ADVISORY COMMITTEE ON REACTOR SAFEGUARDS  
NUCLEAR REGULATORY COMMISSION  
WASHINGTON, D. C. 20555

HIGHLIGHTS OF THE PEAKING FACTORS WORKING GROUP MEETING - AUGUST 20, 1976

MINUTES OF THE ACRS PEAKING FACTORS  
WORKING GROUP  
AUGUST 20, 1976  
WASHINGTON, D. C.

# OUT OF CORE DETECTOR POSITIONS

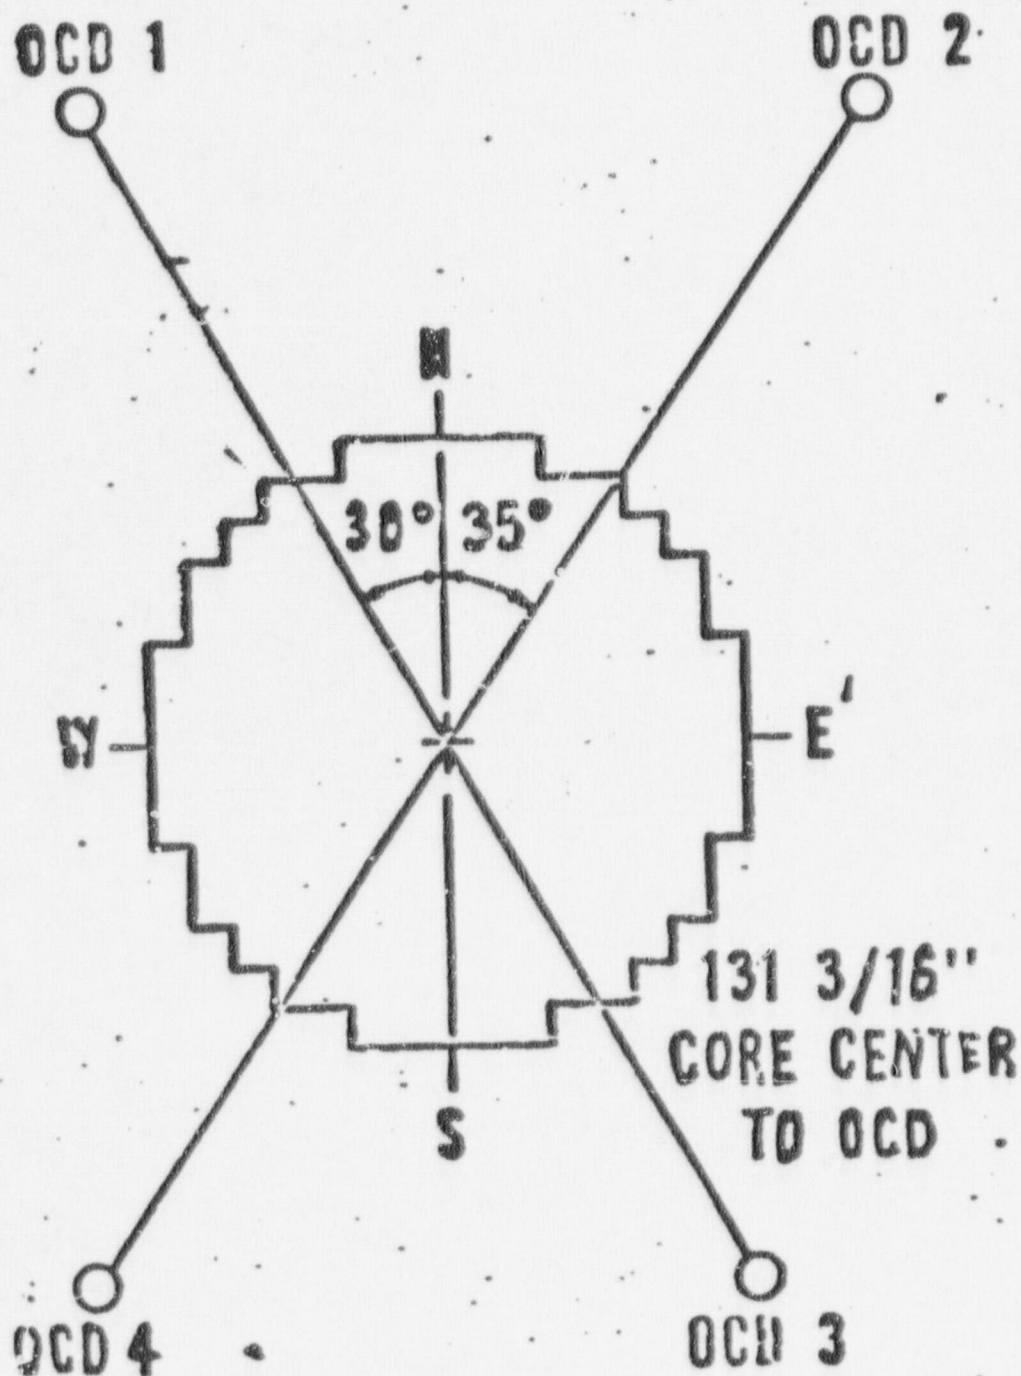
Mr. Brooks described the ex-core detector system used by B&W. The power detection system uses four split uncompensated ion chambers, (Fig. 9). The detectors are not uniformly positioned around the reactor vessel (Fig. 10), due to space limitations.

# OPERATIONAL POWER ENVELOPE

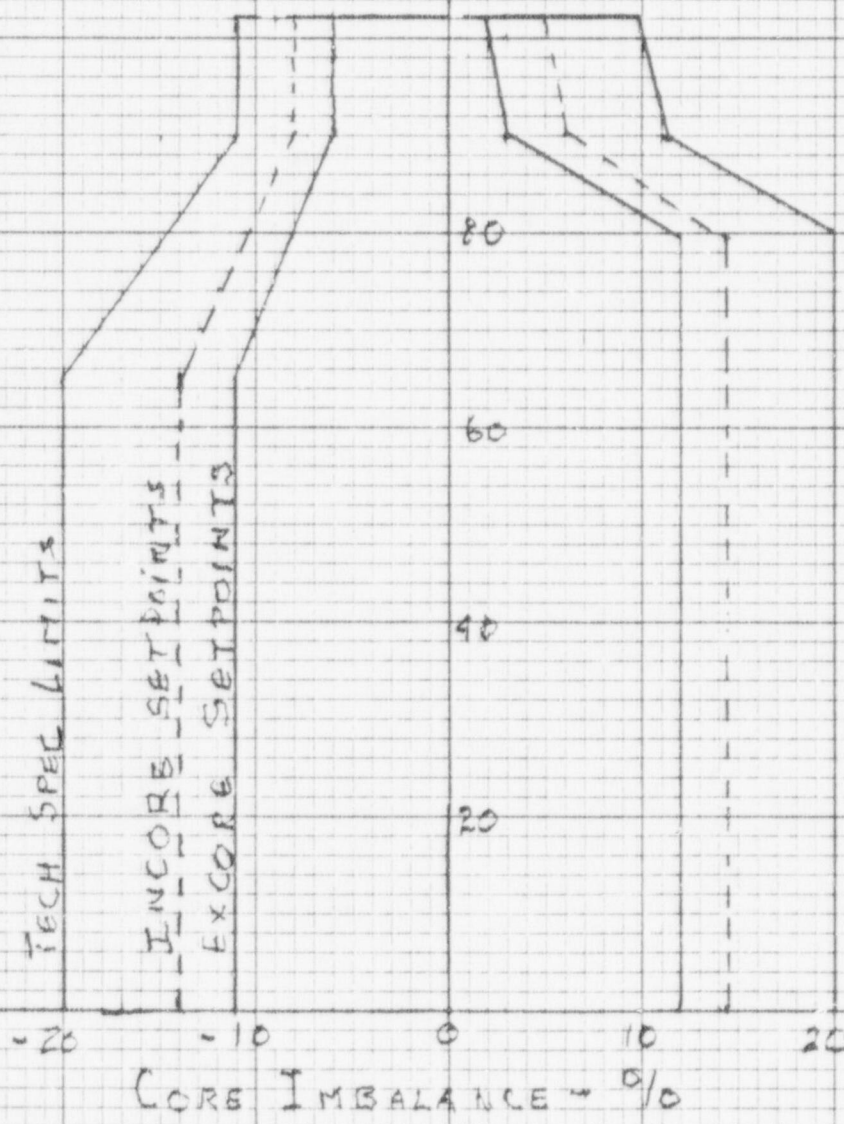
A sample graph of the operational core power "envelope" was shown, (Fig. 15). Responding to Dr. Mark's question, Mr. Dunenfeld said the discontinuity in envelope shape for the positive and negative imbalance values results from the ECCS-LOCA limit curves.

Dr. Lee asked why there is such a restrictive operating band from 80% to 90% power and 90% to 100% power, (Fig. 15). Mr. Gudorf said that because of the transient xenon peaking penalty taken at 90% power and above, and the requirement to maintain LOCA KW/ft. limits, the axial offset has had to be restricted. Below the 90% power level, a larger power peak is allowed, which in turn allows the use of a bigger axial offset.

Figure 3-5. Percent Change in Peak Power Vs Radial Tilt

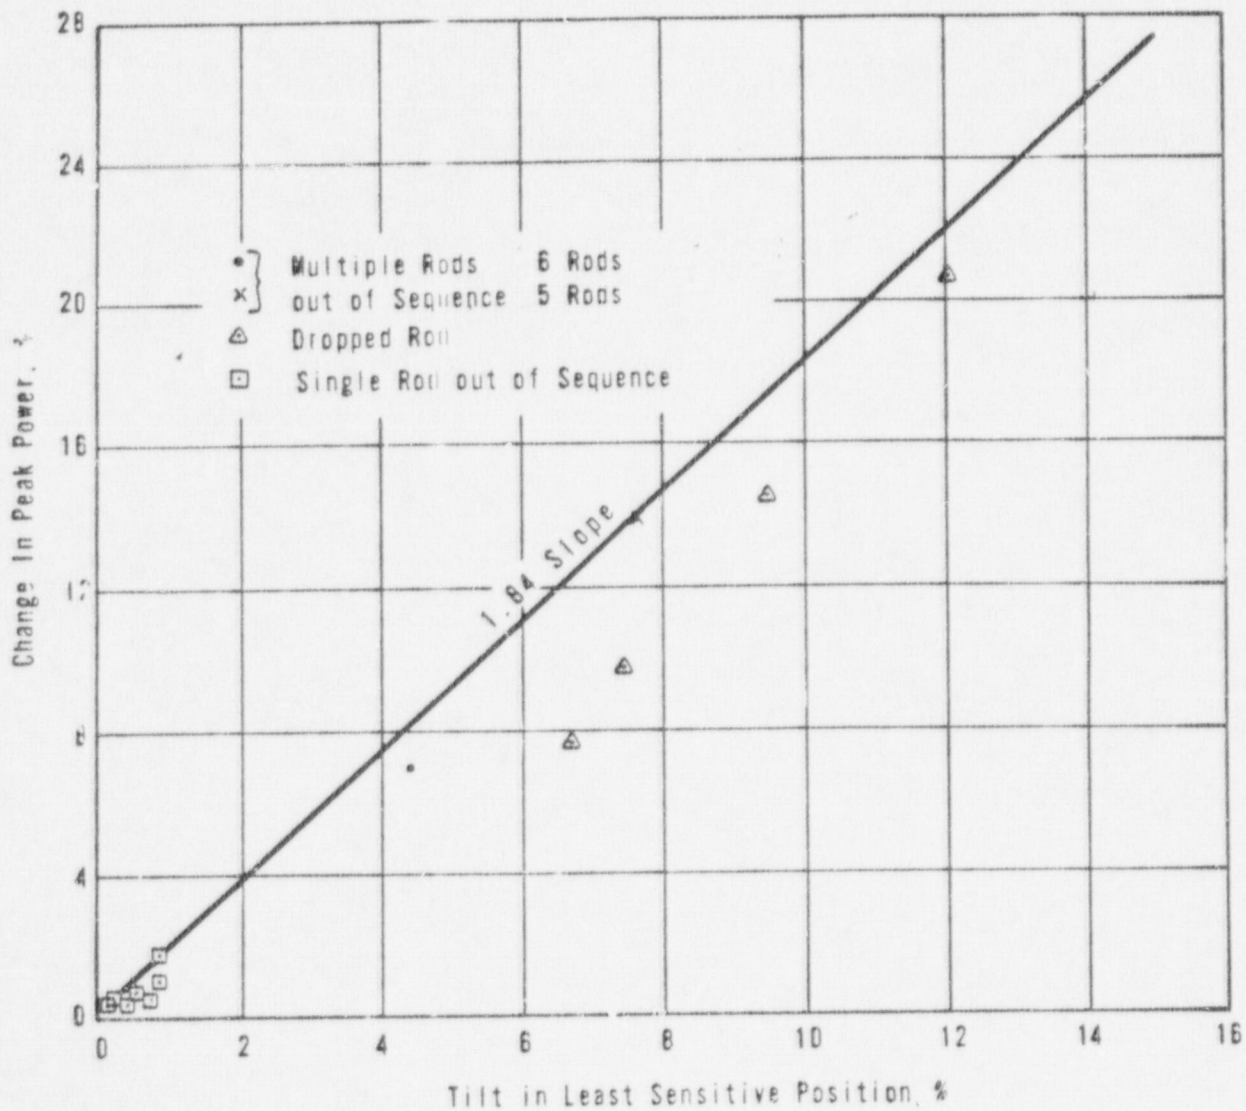
A graph of ex-core radial tilt vs change in peak power was described (Fig. 16). Dr. Kerr inquired as to how the value for the abscissa ("tilt in least sensitive position") is obtained from the ex-core detector outputs. Briefly, the procedure described by B&W was as follows: (1) the four readings from the detectors are summed and an average is determined; (2) for each detector a % deviation from the average is determined; (3) the angle between the tilt direction and the out of core detector must be known. B&W assumes a "least sensitive" angle of  $57.5^{\circ}$  between the tilt direction and the detector location, i.e., at this angle, the detector "sees" the smallest percent of the actual tilt occurring; (4) the change in the power peak as a function of the tilt is determined; (5) the largest positive value determined at step (2) is plotted on the abscissa, and the value for step (4) is plotted on the ordinate.

Mr. Dunenfeld said the line on the tilt vs peak power graph (Fig. 16) envelopes the largest expected change in peak power as a function of ex-core tilt. Mr. Dunenfeld attempted to correlate the slope value (1.84) shown on the above graph to results obtained by W in similar type experiments. Dr. Kerr said that a one-to-one comparison between the two vendors should probably not be made since it is quite likely each vendor has a different definition of "tilt". The Staff is currently studying this problem of comparing peaking factor change via power tilt measurement.
